**Attachment 1
NRC3-10-0006**

**Response to RAI Letter No. 16
(eRAI Tracking No. 3913)**

RAI Question No. 02.05.01-3

Figure 1. Comparison of GIA Model Predictions to Horizontal GPS Data

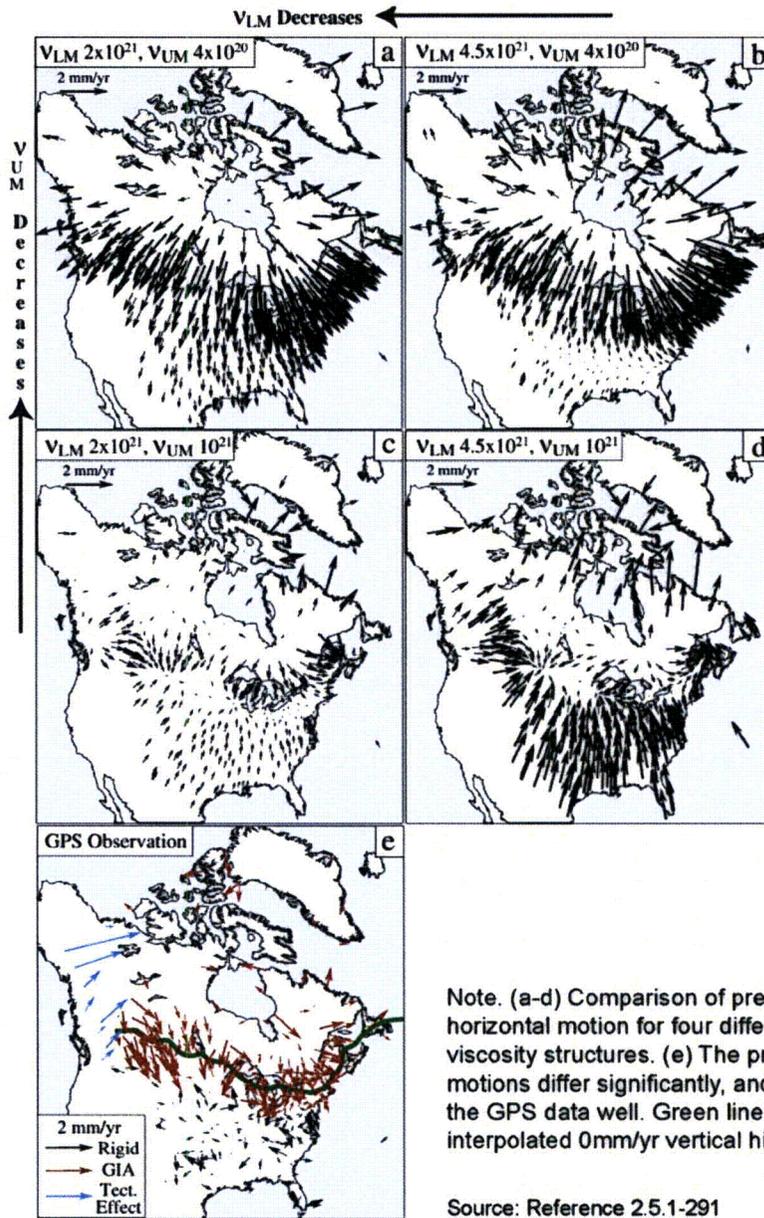
FSAR Sections 2.5.1.1.4.1.1 and 2.5.3.2.2 provide limited discussions on the effects of glacial isostatic adjustments (GIA). FSAR Section 2.5.1.1.4.1.1 states that GIA is “suspected to be a cause of deformation within continental plates and may be a trigger of seismicity in eastern North America and other formerly glaciated regions.” Please provide additional discussion of the following:

- b. The geodetic strain rates that are currently measured in the site region*

Motions from 360 Global Positioning System (GPS) sites in Canada and the United States yield a detailed image of vertical and horizontal velocity fields within the nominally stable interior of the North American Plate (Reference 2.5.1-291) (Figures 2.5.1-253 and 2.5.1-254). Sella et al. (Reference 2.5.1-291) note that by far the strongest signal is the effect of GIA due to ice mass unloading during deglaciation. Vertical velocities show present-day uplift (approximately 10 mm/yr) near Hudson Bay, the site of thickest ice at the last glacial maximum. The uplift rates generally decrease with distance from Hudson Bay and change to subsidence (1 to 2 mm/yr) south of the Great Lakes.

There are no known anomalies or strain gradients in the site region that are inconsistent with the GIA deformation pattern or are of sufficient amplitude to be detected. Horizontal motions show outward motions from Hudson Bay with complex local variations, especially in the far field (Figure 2.5.1-254). Comparison of GIA model predictions using four different upper mantle viscosity models to residual horizontal motions created by removing rigid plate motion from the GPS data shows significant misfits that are likely due to uncertainties associated with the ice load history, and to the assumption of laterally homogeneous rheology (Figure 1). Some of the horizontal scatter may reflect a combination of local site effects (noise) and intraplate tectonic signal. (Reference 2.5.1-291)

Figure 3. Glacial Lake Inundation and Outlet Controls.

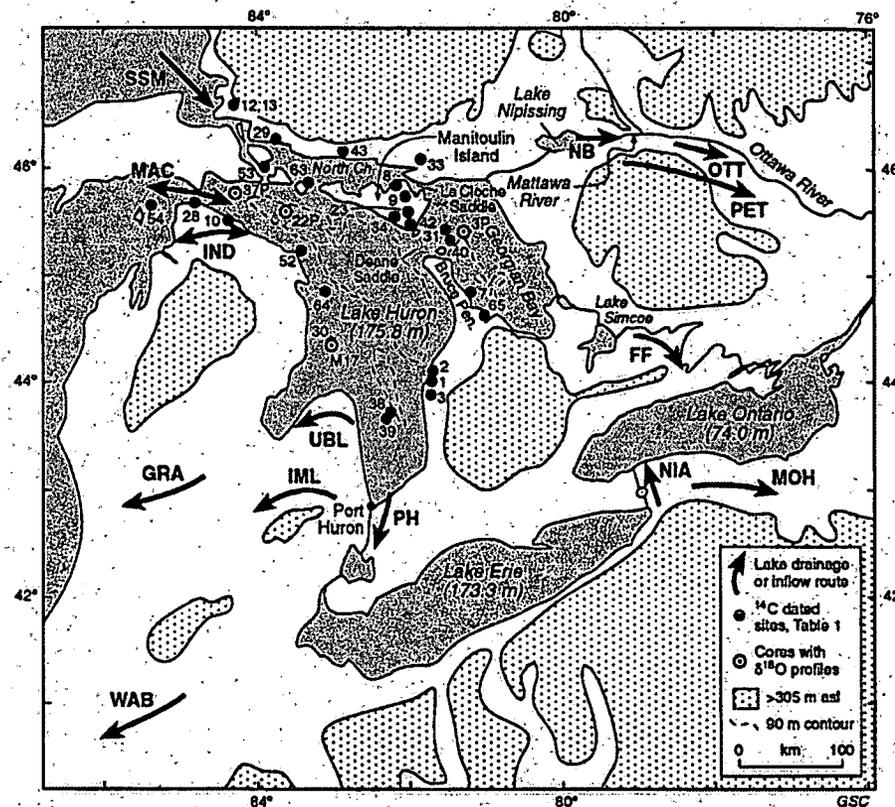
- d. *Any deformed glacial shorelines and whether or not the shoreline deformation can be explained solely by GIA processes*

Farrand (Reference 2.5.1-295) discusses evidence for uplift at Port Huron, which is the major outlet for glacial lakes as well as present-day Lake Huron (Figure 3). The earliest shorelines recorded at Port Huron, which have been uplifted 18 m (59 ft) show no differential uplift from earliest to latest Maumee times. Glacial Lake Whittlesey, the next youngest glacial lake, has been uplifted about 8.2 m (27 ft), and the Warren beach at Port Huron now lies at 215 m (705 ft), suggesting about 5.2 m (17 ft) of uplift. The Grassmere, Lundy, and Algonquin beaches at Port Huron exhibit no uplift. Farrand (Reference 2.5.1-295) therefore concluded that the rate of postglacial uplift (rebound) was very great at the time of deglaciation but it decelerated rapidly toward the present day.

Figure 2.5.1-202 Fermi 3 Site Regional Physiographic Map

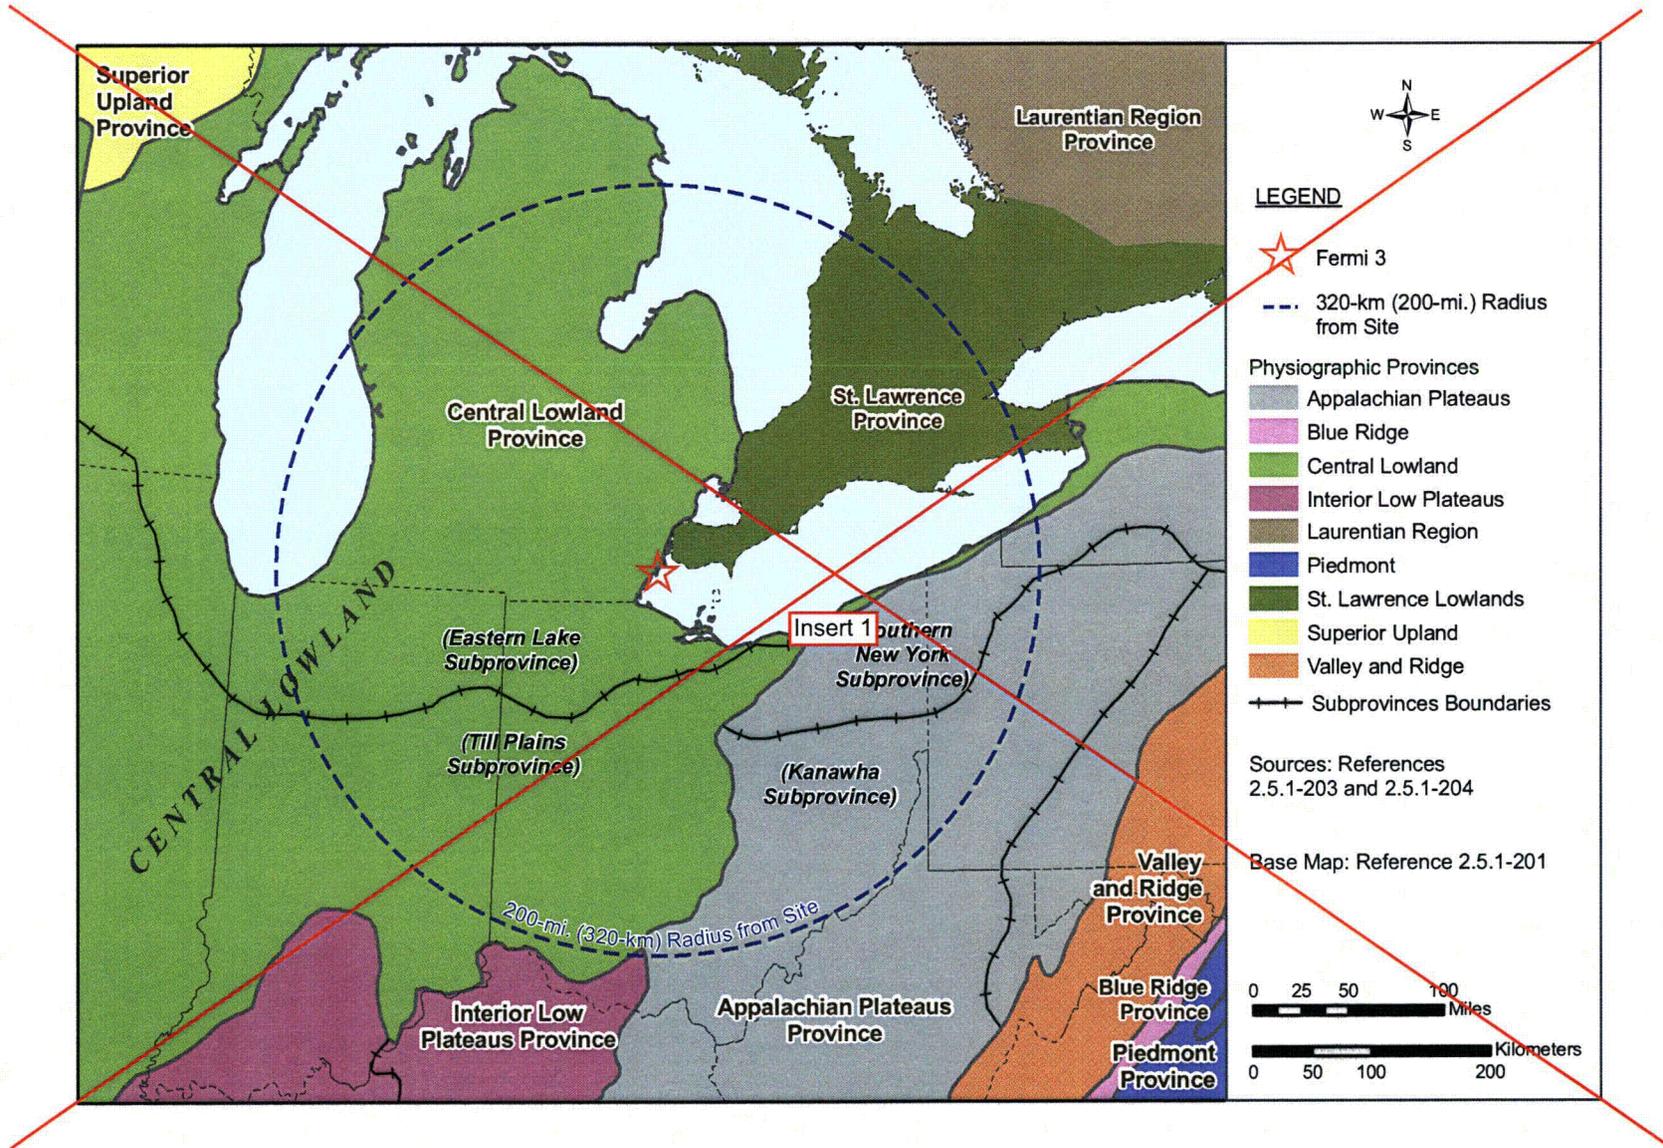
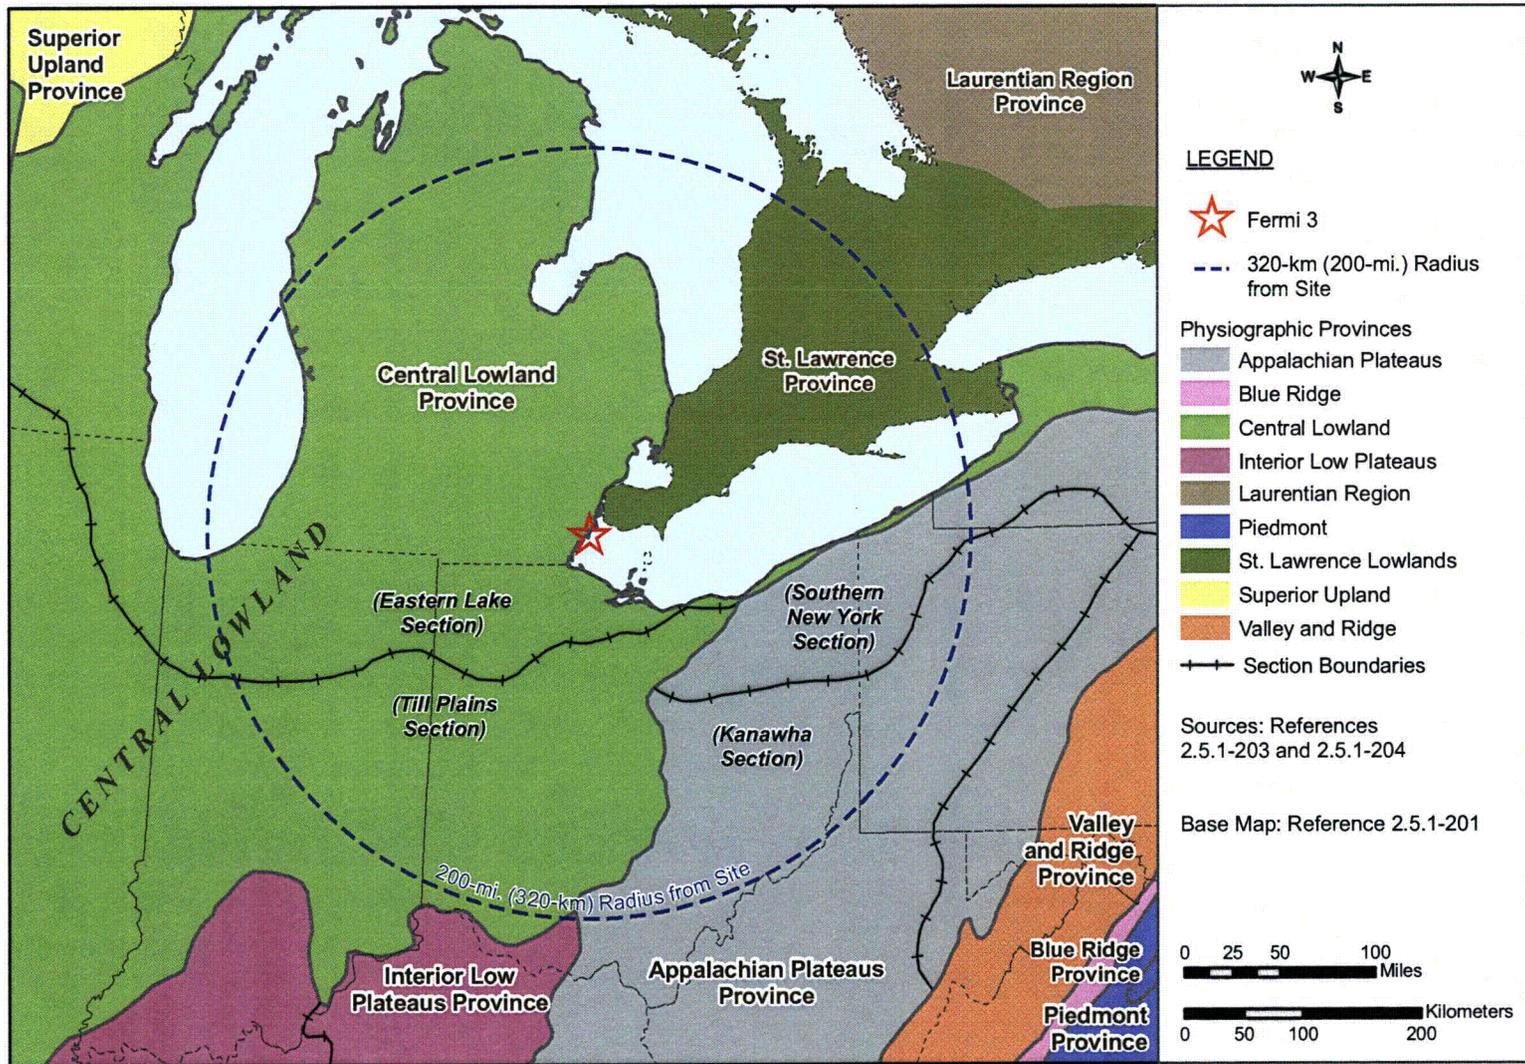
FSAR Section 2.5.1.2.1 describes the physiographic subdivisions in the site vicinity. The St. Clair clay plain and the Maumee Lake plains are not shown on the regional physiographic map (FSAR Figure 2.5.1-202). Please include these subdivisions in the context of the overall physiographic framework, either on this map or on a larger-scale map showing the physiography of the site vicinity. Also, the term "section" is used within the FSAR text, but "subprovince" is used on the map. Please clarify the appropriate terminology.

- a) FSAR Section 2.5.1.2.1 makes reference to the St. Clair clay plain and the Maumee Lake plains that are not shown in the Rev. 1 FSAR figures. A new figure (FSAR Figure 2.5.1-250) will be added showing the extent of these two regions in the site vicinity along with other physiographic regions outside the 40 km (25 mile) radius site vicinity. The Maumee Lake plains region is a subdivision of the Eastern Lake section developed by the Division of Geological Survey for the State of Ohio (FSAR Reference 2.5.1-219) and is labeled on Figure 2.5.1-250 as "Eastern Lake Section – Maumee Lake Plains". Since the State of Michigan has not subdivided the Eastern Lake section, the area of the Figure 2.5.1-250 in Michigan is labeled as "Eastern Lake Section – undifferentiated". A modification of FSAR Section 2.5.1.2.1 citing this figure has been made.

- b) Fenneman and Johnson (FSAR Reference 2.5.1-203) use the following hierarchy for the Physiography of the United States: Divisions, Provinces, and Sections. The U. S. Geological Survey continues to use the same hierarchy. A revision to FSAR Figure 2.5.1-202 is provided with "Subprovince" replaced with "Section".

Figure 2.5.1-266 Earthquakes and Inferred Fault Planes in the Ashtabula, Ohio, Area

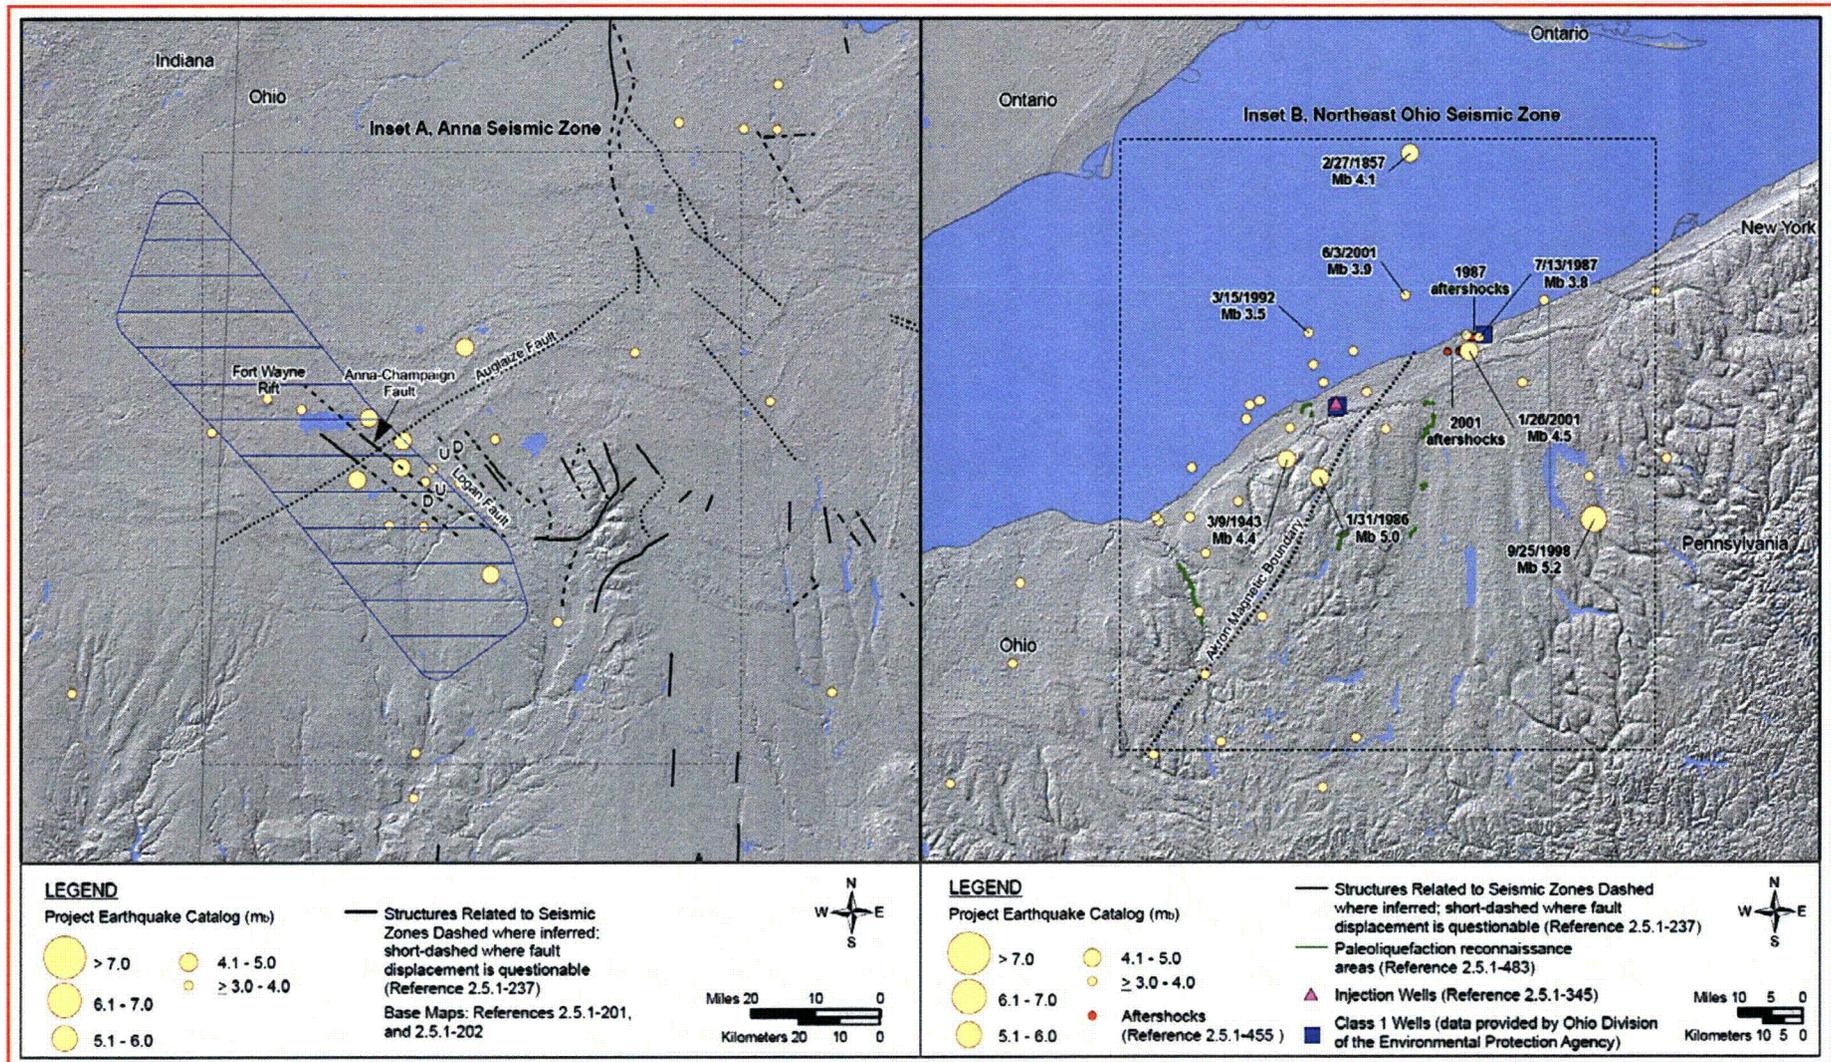
Response

Seeber et al. (Reference 2.5.1-455) discuss these fore-main-aftershock sequences and interpretations of these events based on information obtained from three short-term deployments of portable seismographs (in 1987, 2001, and 2003) and from regional broadband seismograms. The main observations and conclusions from this analysis are as follows:

- A persistent earthquake sequence in northeast Ohio includes multiple distinct fore-main-aftershock sequences that illuminate two faults approximately 4 km (2.5 mi) apart.

- The seismicity is closely associated with the injection of waste fluid from 1986 to 1994 into the basal Paleozoic formation.
- All the earthquakes originated from a relatively small area (~ 10 km [6 mi] wide) and are assumed to form a single sequence of causally related earthquakes.
